# GRANDVIEW RESERVE METROPOLITAN DISTRICT ON SITE SANITARY SEWER CONSTRUCTION DOCUMENTS

AND EROSION CONTROL PLANS  
COUNTY OF EL PASO, STATE OF COLORADO

D.R. HORTON - GRANDVIEW RESERVE  
ON-SITE SANITARY SEWER  
DESIGN & PERMITTING SERVICES  
EL PASO COUNTY  
PEYTON, CO

## Comment response for ON SITE SANITARY SEWER

CIVIL  
 PLAN AND PROFILES STA. 12+50 TO STA 24+50

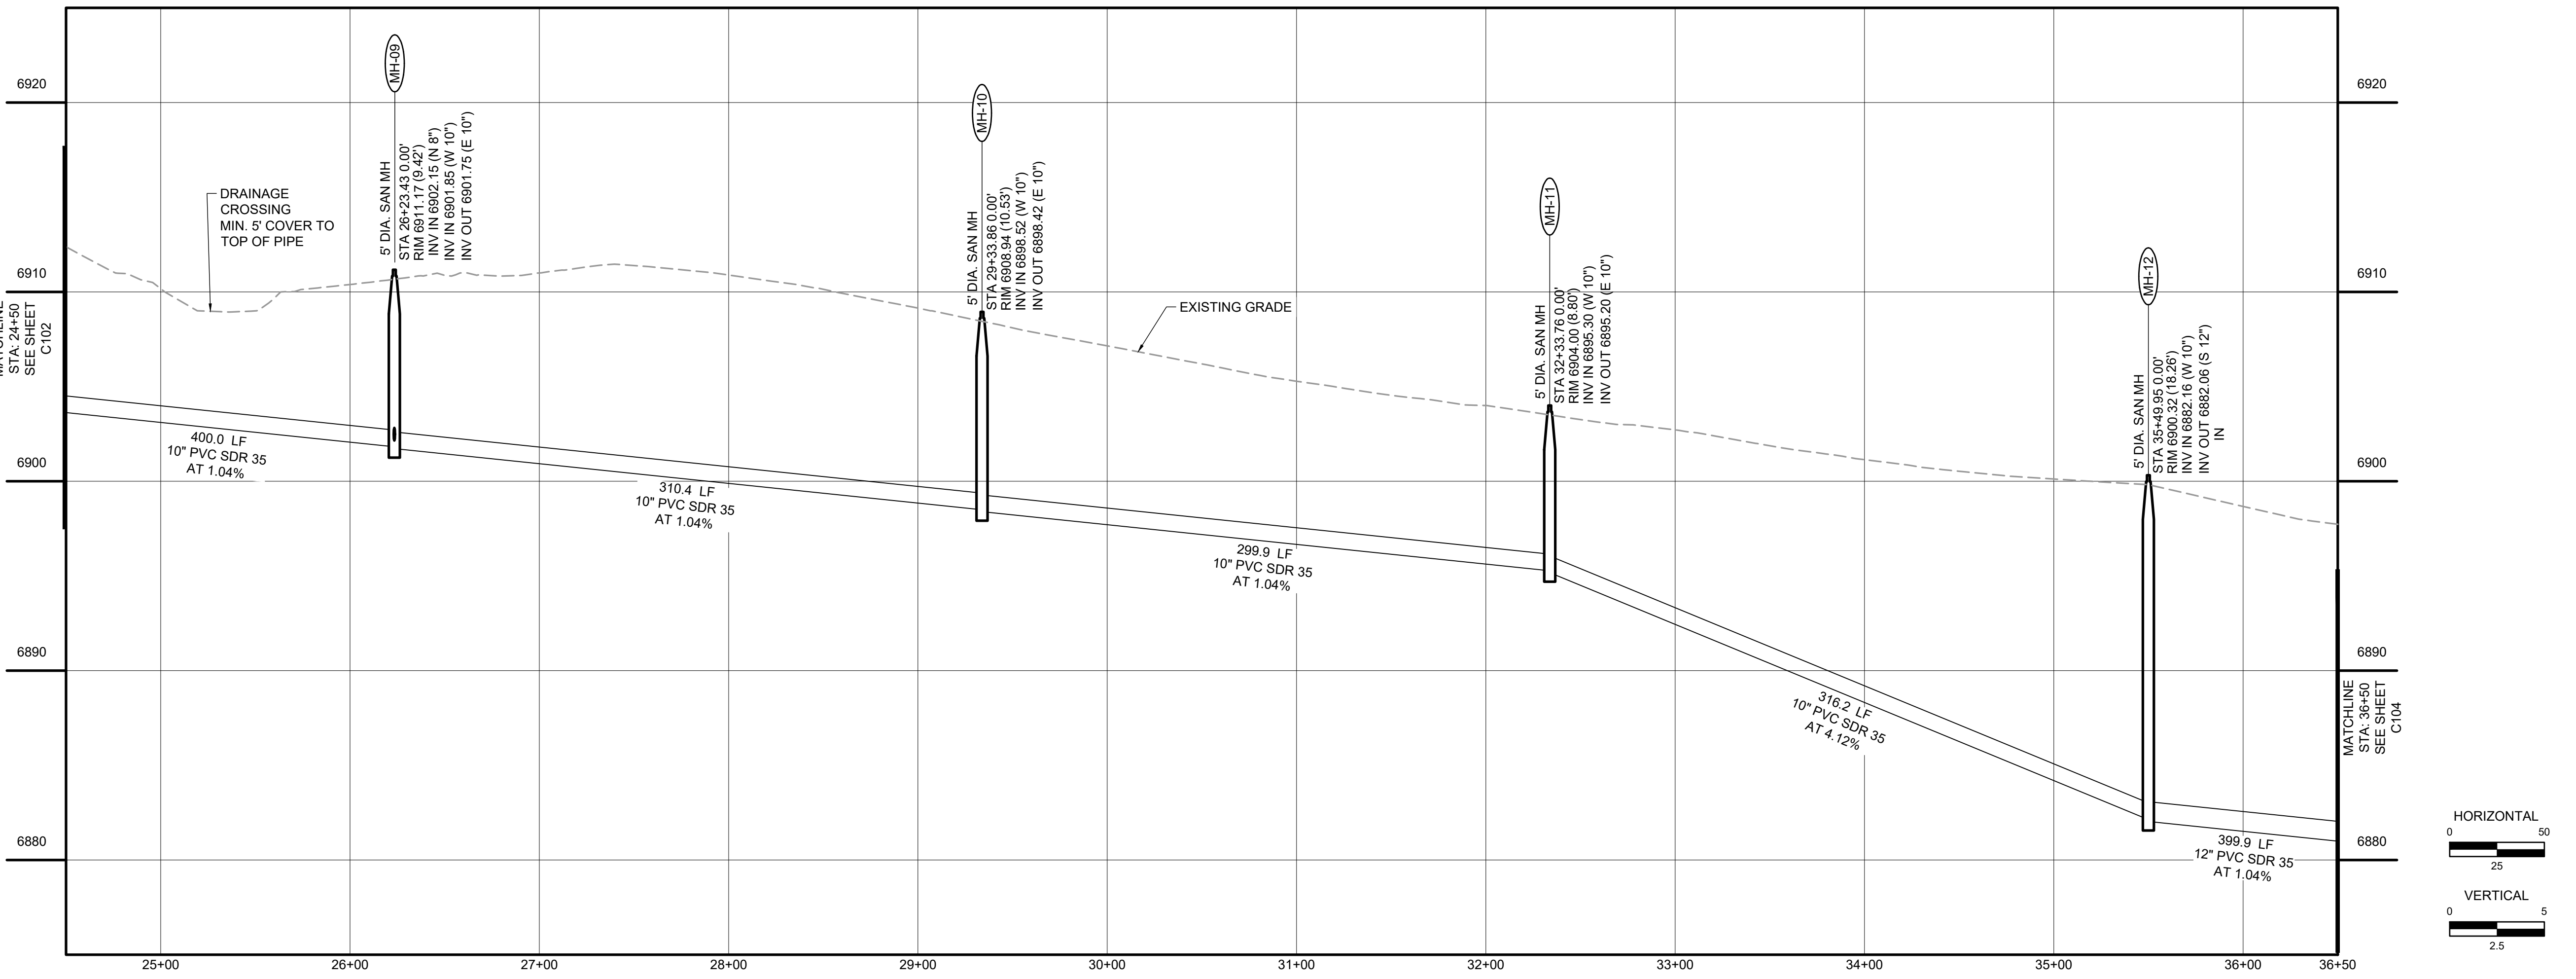
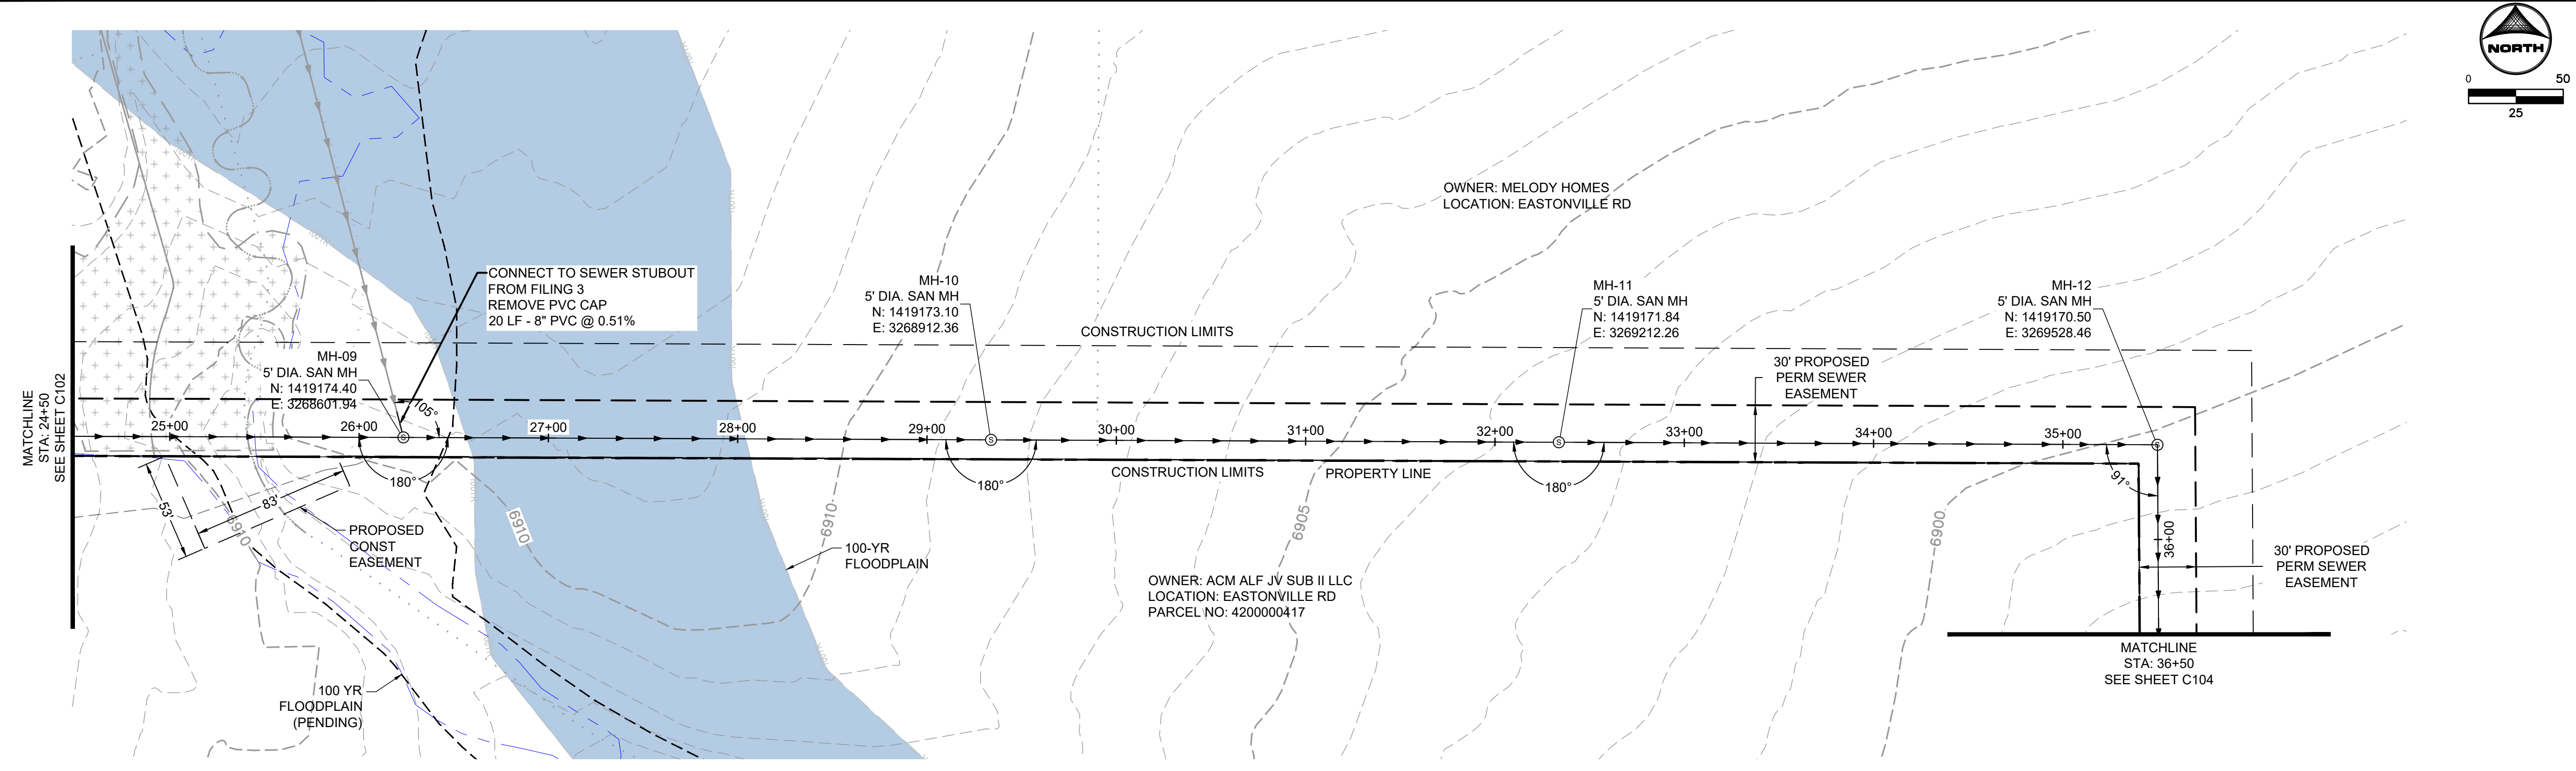
Page No	Comments	Response
6	Unresolved: Label if this easement is for utilities, drainage, access, etc	Removed. Easement not apart of this project.
7	Provide hatching or linework to show these limits	Arrow should be on the boundary wetland limit (resolved)
